Title: Advisory Committee on Reactor Safeguards
Subcommittee on Power Upgrades

Date: Tuesday, November 29, 2005

5 Entergy would like to thank the Committee
6 for this opportunity to continue our discussion about
7 the Entergy Vermont Yankee extended power uprate. For
8 today's first session, we will be discussing the steam
9 dryer analysis, modification, and monitoring program.

Figure 1: Modification Locations

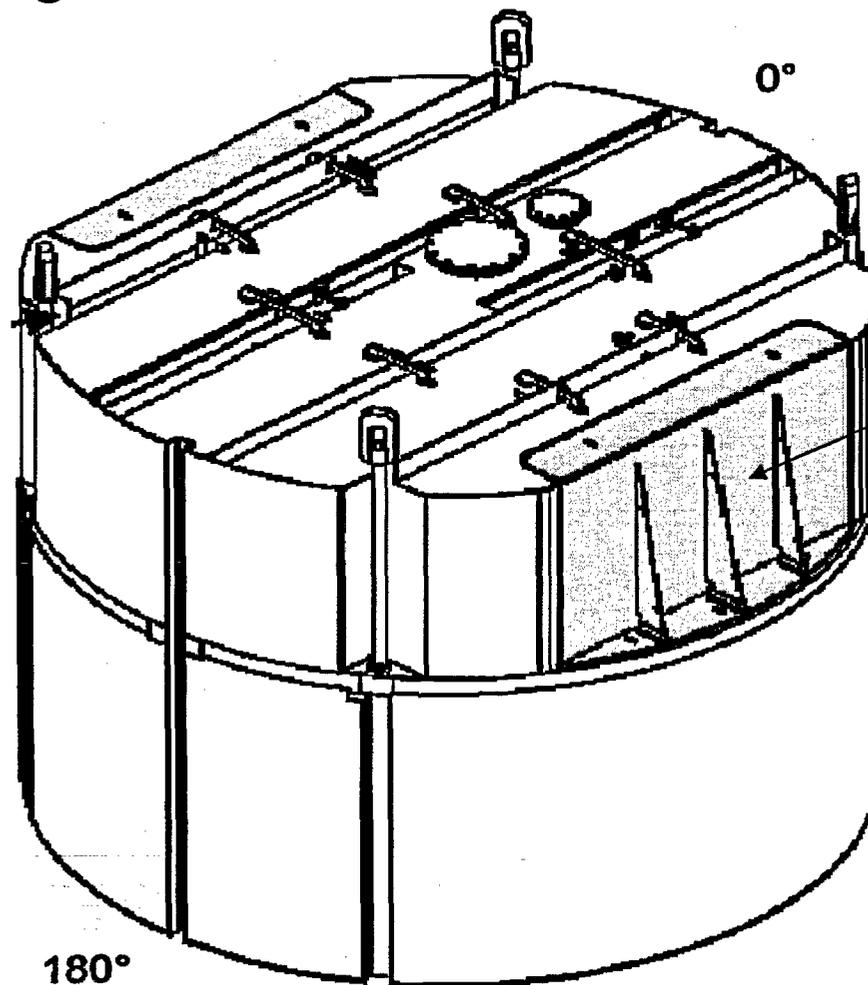
10 MEMBER SIEBER: Before you leave this
11 picture, it seems to me that I recall that this dryer
12 does not have the perforated mesh plates in it that
13 lighter dryers have and that you intend to install
14 them. Can you show me where those would fit on here?

2 The VY dryer modification installed in
3 April 2004 consisted of strengthening of areas
4 adjacent to the main steam line nozzle shown here in
5 the highlighted locations, which are vulnerable, as
6 shown in other BWRs with square hood dryers.

7 The modification consisted of replacement
8 of the original half-inch outer hood vertical plate,
9 which you can see here is the area on the vertical
10 portion of the front hood.

11 Also, we replaced the original
12 quarter-inch-thick lower horizontal cover plate with
13 five-eighths-inch-thick plate. We added 3
14 55-inch-tall gussets to the outer vertical plate and
15 cover plate junction to increase stiffness.

15 MR. HOBBS: We do not plan to install
16 perforated plates. We have a steam separator that is
17 highly efficient relative to other BWR-free units. So
18 our steam quality coming out of our separator is high
19 enough that we can work without having a perforated
20 plate.

Figure 3: Completed Modification – Outer Hood, Cover Plate, Gussets

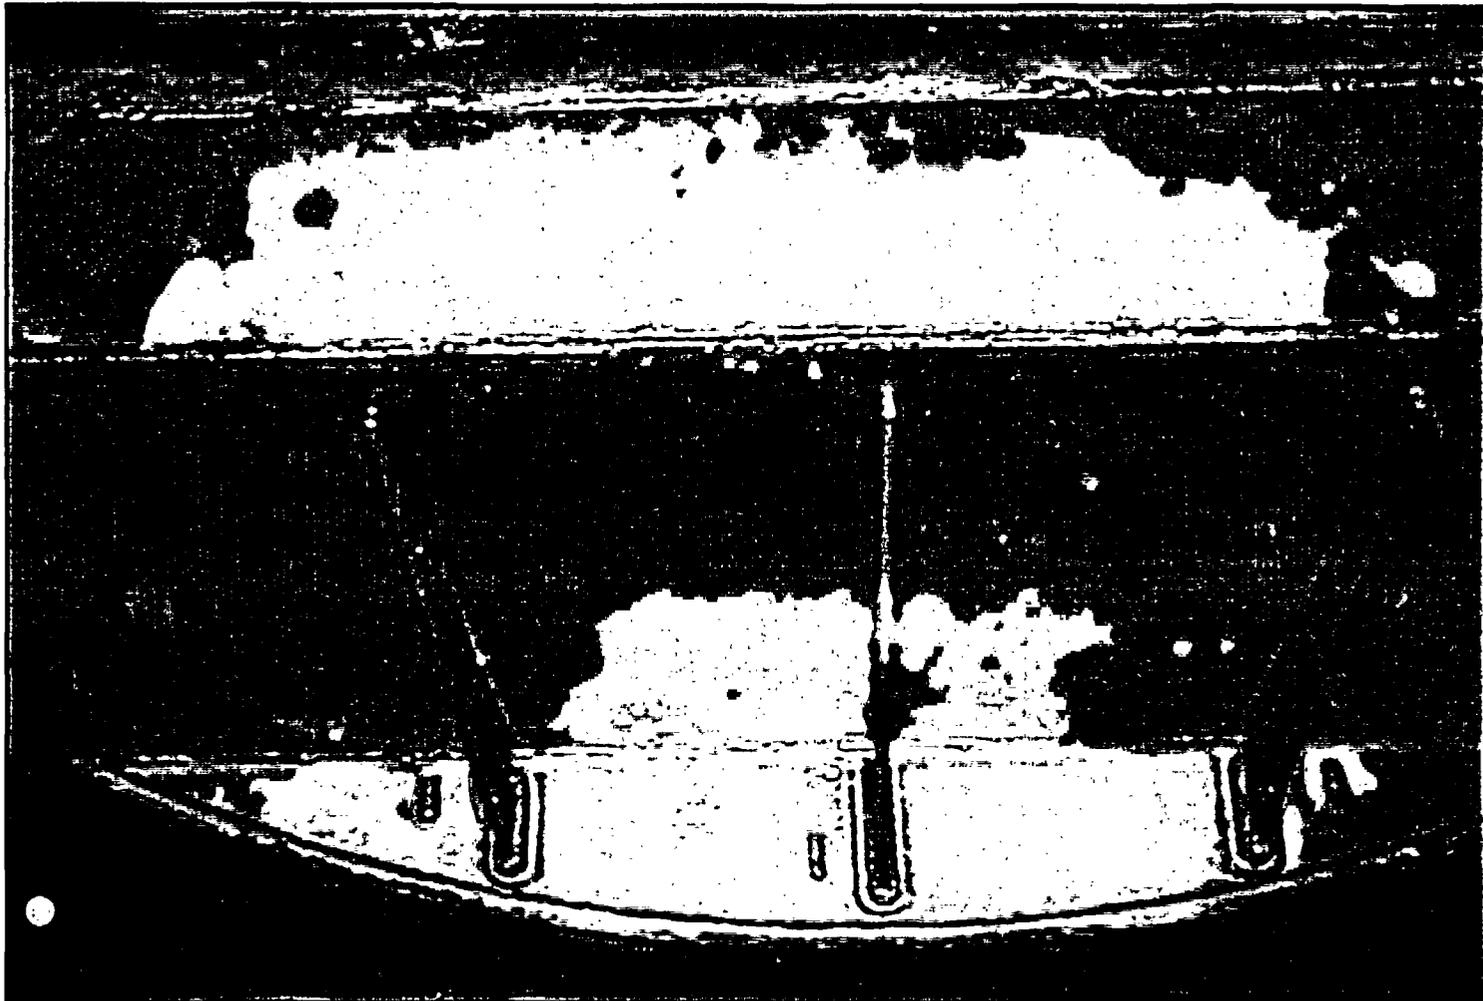
12 DR. BANERJEE: Now, if you don't remove
13 whatever is causing the vibration, this is going to
14 continue to vibrate, right? And eventually it will
15 crack again or not?

15 DR. BANERJEE: Adding those gussets, of
16 course, gives you additional vortex shedding because
17 the flow goes across them now. So you've added some
18 additional sort of modes due to those gussets
19 themselves, --

15 MR. HOBBS: Right. This is a photo of the
16 modification being installed in 2004. And this shows
17 the completed Vermont Yankee dryer-strengthening
18 modification. Here you can see the new gussets and
19 the new faceplate and the lower cover plate.

5 So this modification takes care of some of
6 the low-frequency excitations that typically can occur
7 inside the domes themselves. And it moves the
8 fundamental vacancy of this dryer face well above the
9 standard frequencies, driving frequencies. So it
10 keeps the structure coupling with the --

3 MR. BETTI: Right. We didn't have
4 problems in this dryer in this area prior to the
5 modification, but we based it based on what GE felt
6 was a design that would take its fundamental frequency
7 above what typically for BWR systems are the
8 recognized frequencies of concern.

Figure 5a: VY Strain Gage Measurements vs. Quad Cities (Log) Steam Line Data PSD Comparison QC2 (OLTP & EPU) vs. VY 100% (CLTP)

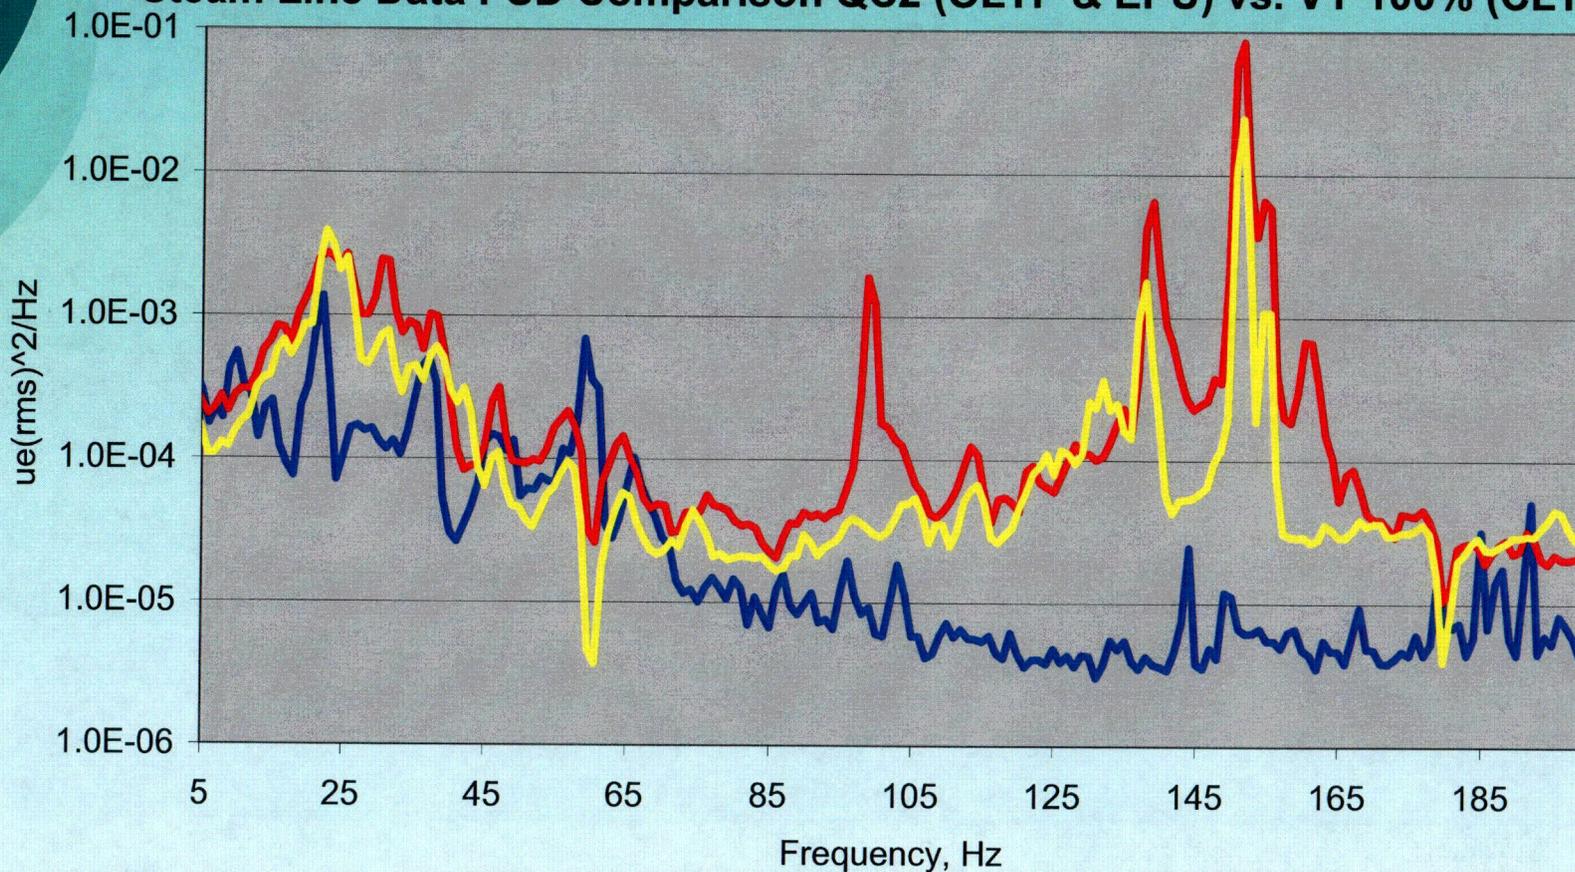
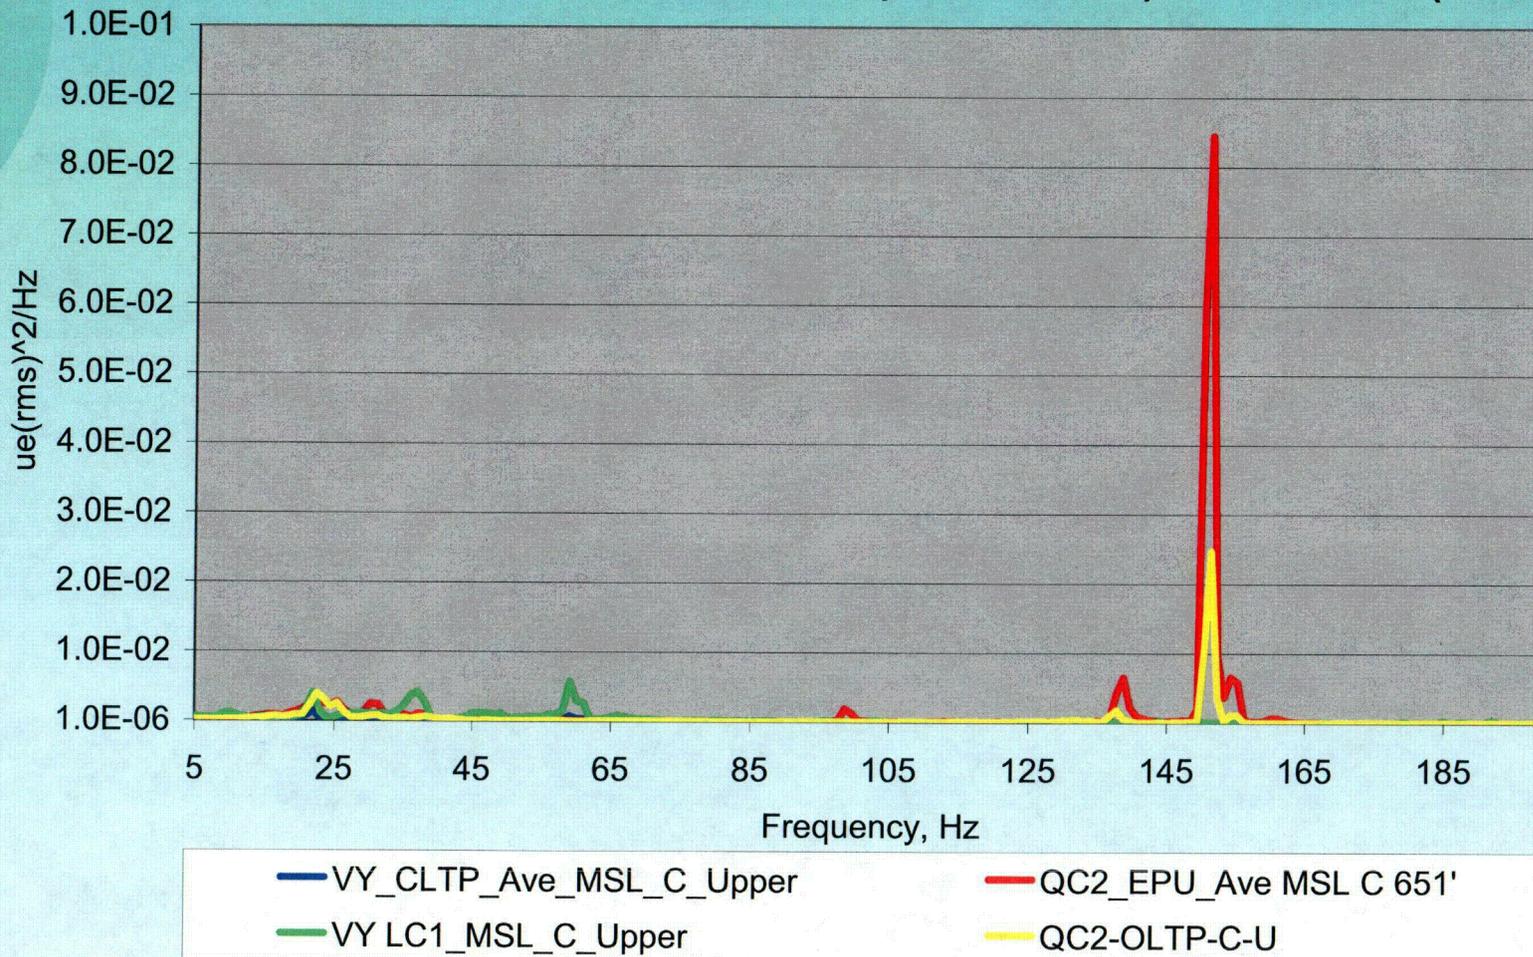
7 CHAIRMAN DENNING: Another comment. And
8 that is now the frequency at which we saw in Quad
9 Cities, this big peak, is way above the area that is
10 related to where your strengthening occurred, right?

18 Next slide. This figure adds the Quad
19 Cities vibration data in log-scale still for operation
20 at EPU conditions. And if you go to the next slide,
21 this is on a linear scale.

22 So you can see that there is a significant
23 increase in the Quad Cities acoustic resonance levels
24 at EPU conditions in this figure here. And at Quad
25 Cities, EPU exacerbated the previously existing

Figure 6: Potential Cavity Resonance Range vs. Main Steam Velocity

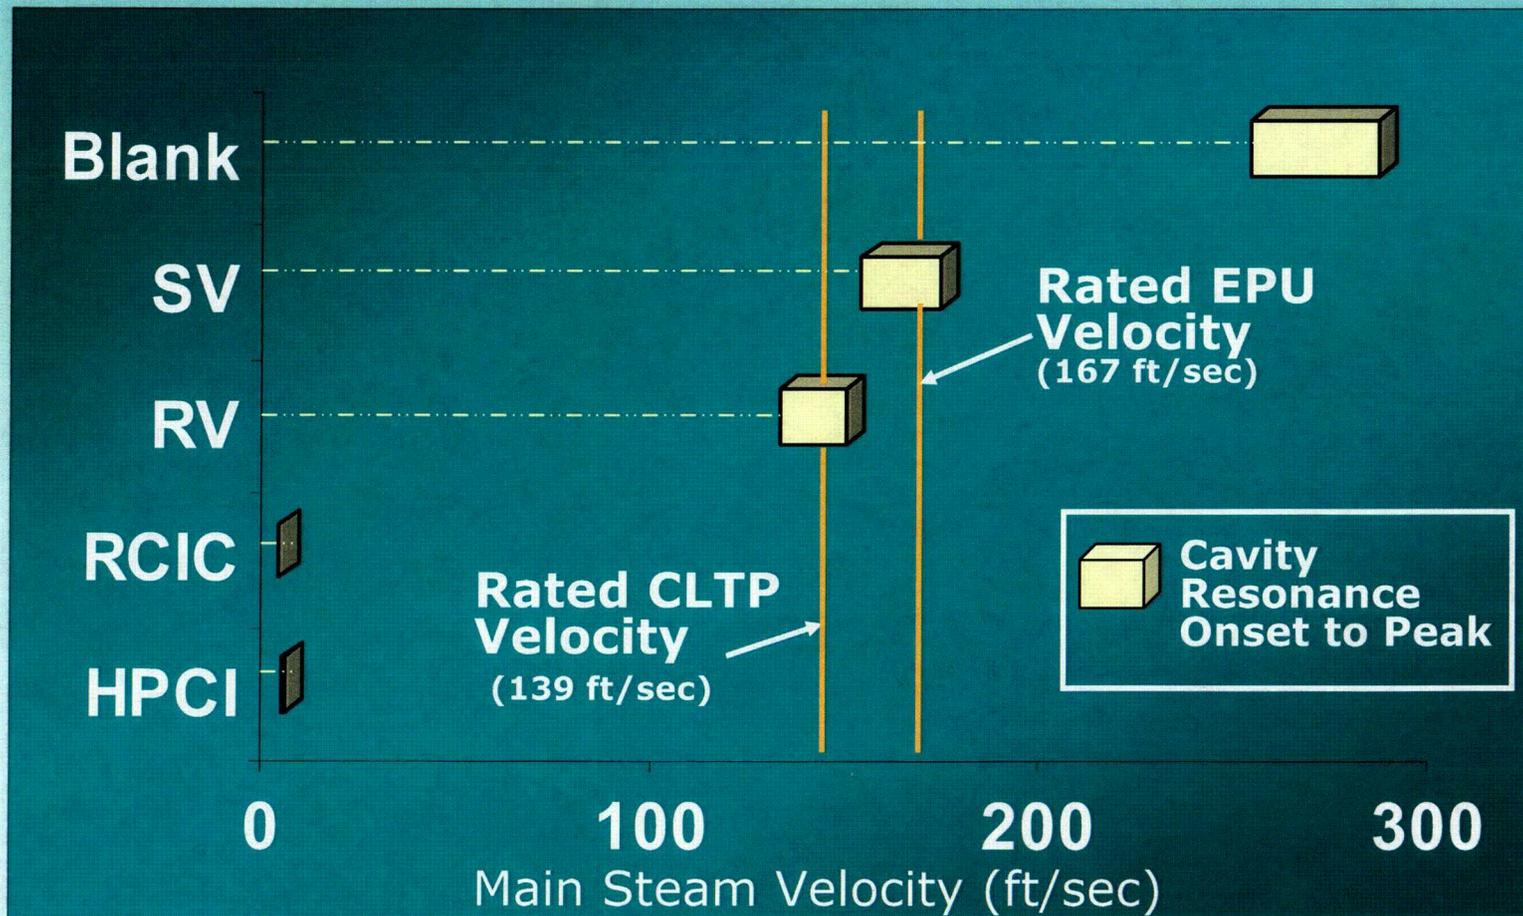
21 DR. BANERJEE: Just a question. At the
22 entrance to the steam line and that cavity which is
23 formed at the dryer, is there sort of potential for
24 resonances there?

11 And you can see that for the rated current
12 Vermont Yankee velocity of 139 feet per second, the
13 relief valves have predicted onset of resonance and
14 full resonance in that block there. And at EPU
15 condition, you can see the safety valves would show
16 potential onset for resonance.
